| **Subject:** | Fw: 2019-06-18 # Tract 50666 # Request for Storm Drain Amendment |

SAWAYA ENGINEERING CONSULTANTS, INC.
*CIVIL ENGINEERING • LAND PLANNING • SURVEYING*

Re: **Request to use Forestall Canyon to convey off-site storm water in lieu of the proposed 60 inch Reinforced Concrete Pipe.**

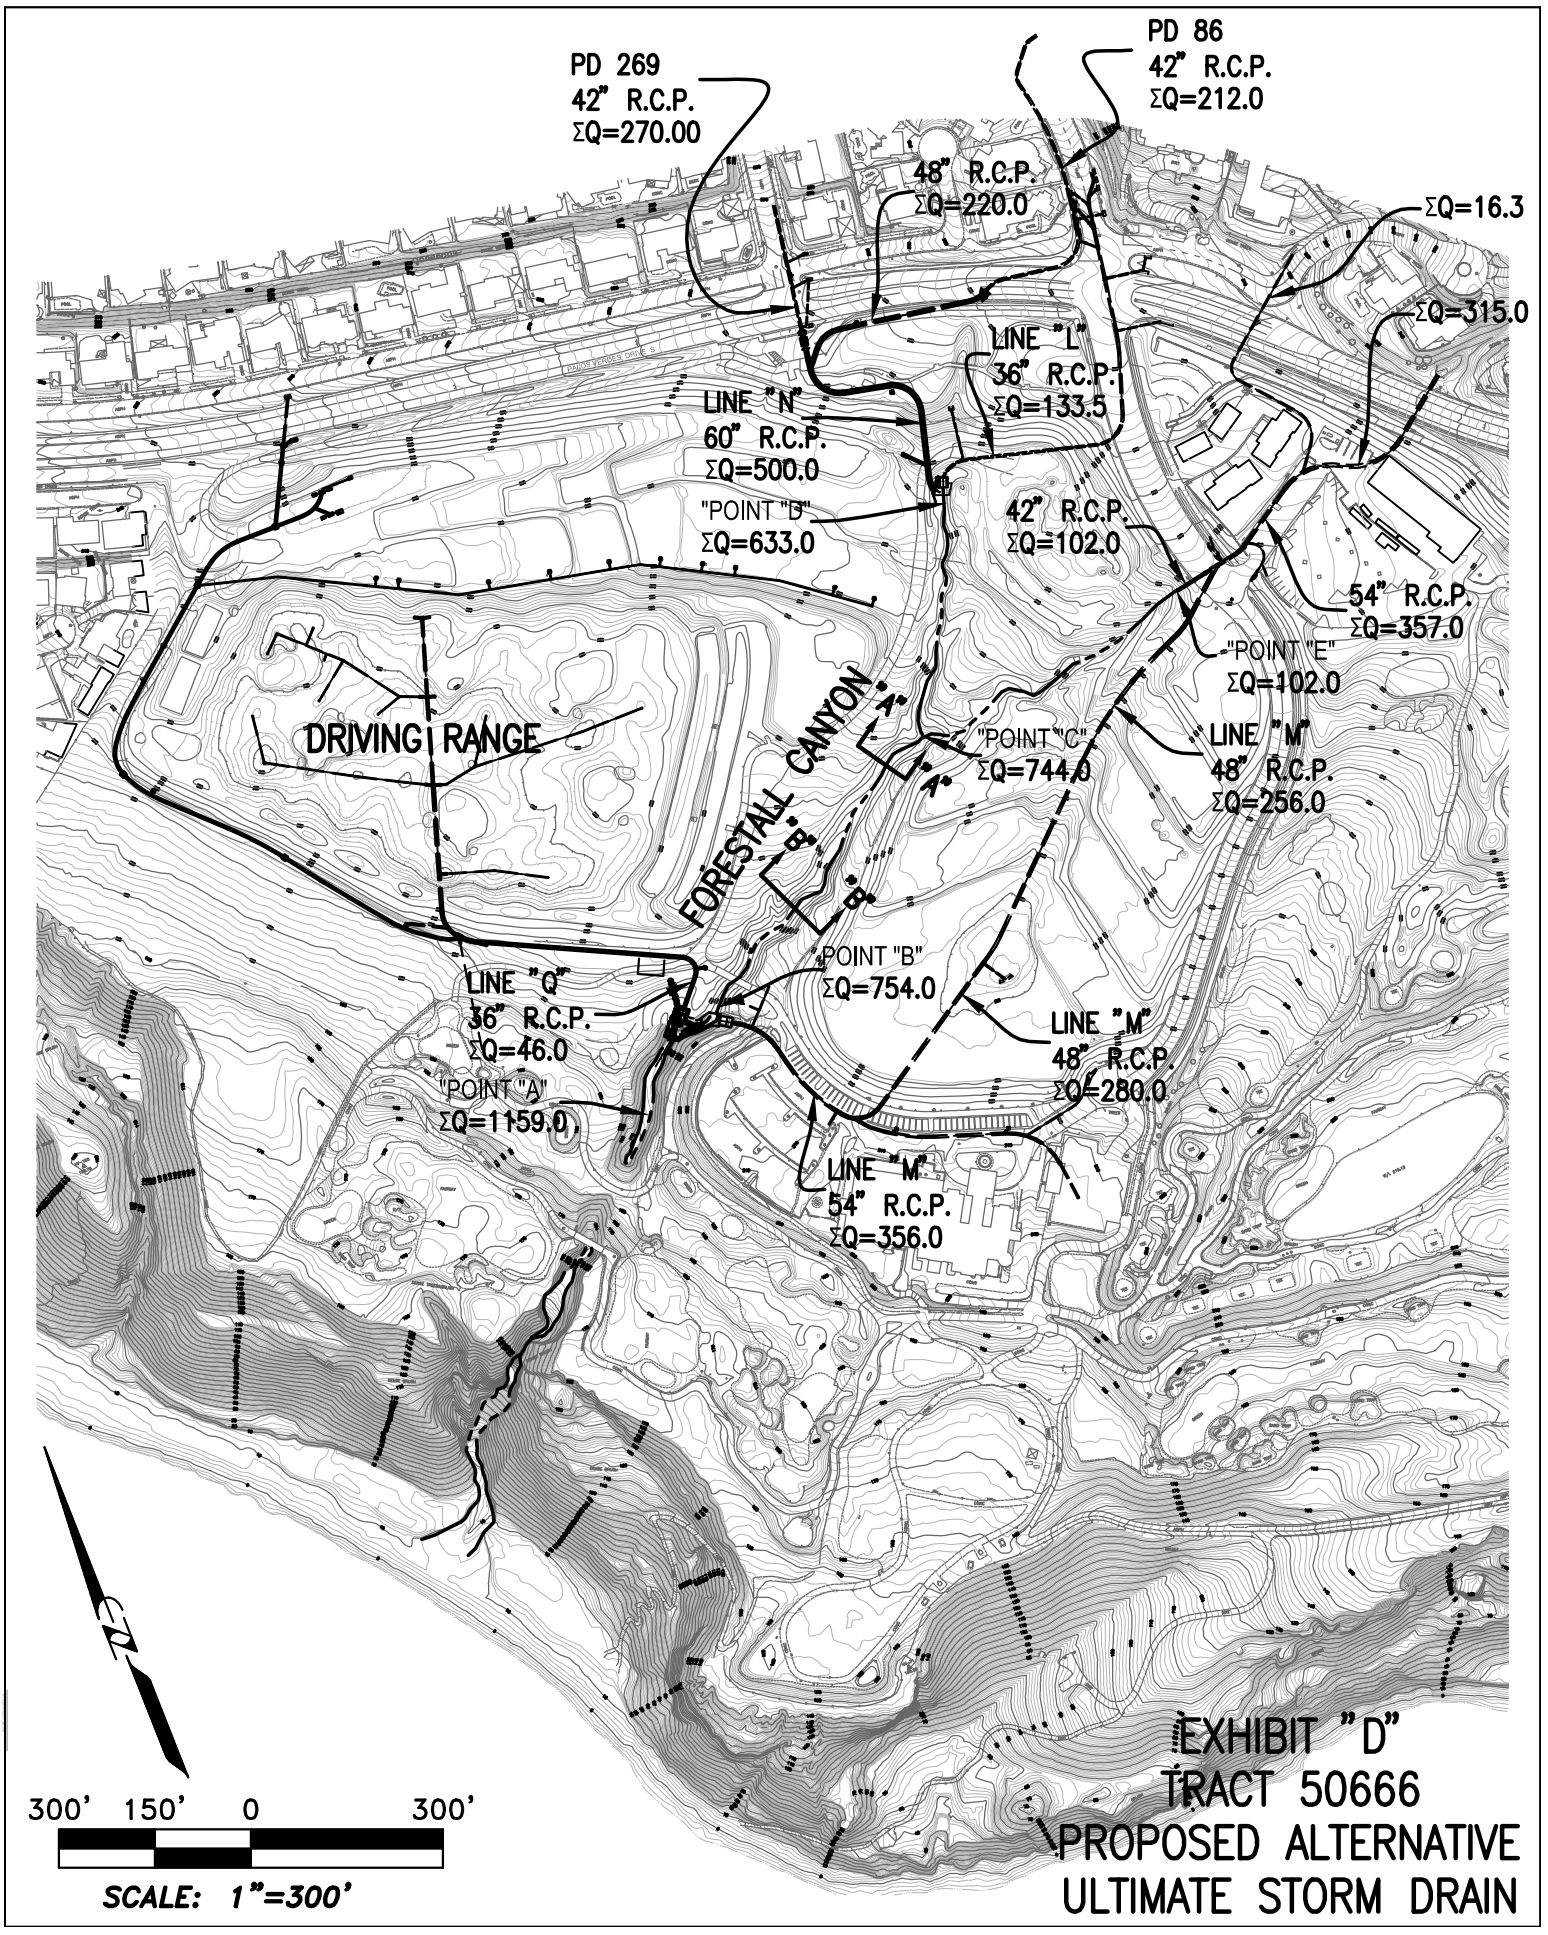
In 2005, an amended loting configuration for the site was approved and graded to provide for a driving range in lieu of 16 residential lots, thus reducing the number of residential lots west of Forestall Canyon from 29 to only 13 lots. The amended site as approved and graded has reduced and likely eliminated the risk of residential flooding from Forestall Canyon rendering the proposed Line "N" (60" RCP) redundant and unnecessary. Therefore, VH Property is requesting the City of Rancho Palos Verdes' approval to eliminate the portion of Line "N" that is adjacent to Forestall Canyon from Point "B" to Point "D".

1. The proposed ultimate flow of Forestall Canyon would be approximately 72% of historical (Predevelopment at Point "B" is 1050 cfs – Post development at Point "B" is 754 cfs).
2. The proposed ultimate flow of Forestall Canyon would be equal to the current/interim flow.
3. Forestall Canyon has performed well under the current/interim condition for the past 15 years.
4. No Residential lots would be at risk from flooding and high velocity scouring action.
5. Forestall Canyon has the capacity to carry the anticipated flow with a velocity less than 15 fps. (See Exhibit "E" for Hydraulic Calculation).
6. Since PD 86 and PD 269 are debris carrying line, Forestall Canyon is more suitable to carry the flow rather than a storm drain pipe.

7. The construction of Line "N" is very intrusive to the area due to its size (60") and depth (20').
8. Line "N" if constructed would be a debris carrying line with a pipe diameter of 60 inch at a minimum slope of 5%, carrying a flow of 549 cfs, resulting in a velocity of at least 38 fps. This would require a large outlet structure / riprap pad configuration which would be intrusive to the ecosystem of Forestall Canyon.
9. The Operator of the Golf Course is bound by a maintenance agreement with the City of Ranch Palos Verdes, which covers the extent of maintenance liability over Forestall Canyon and all outlet structures.
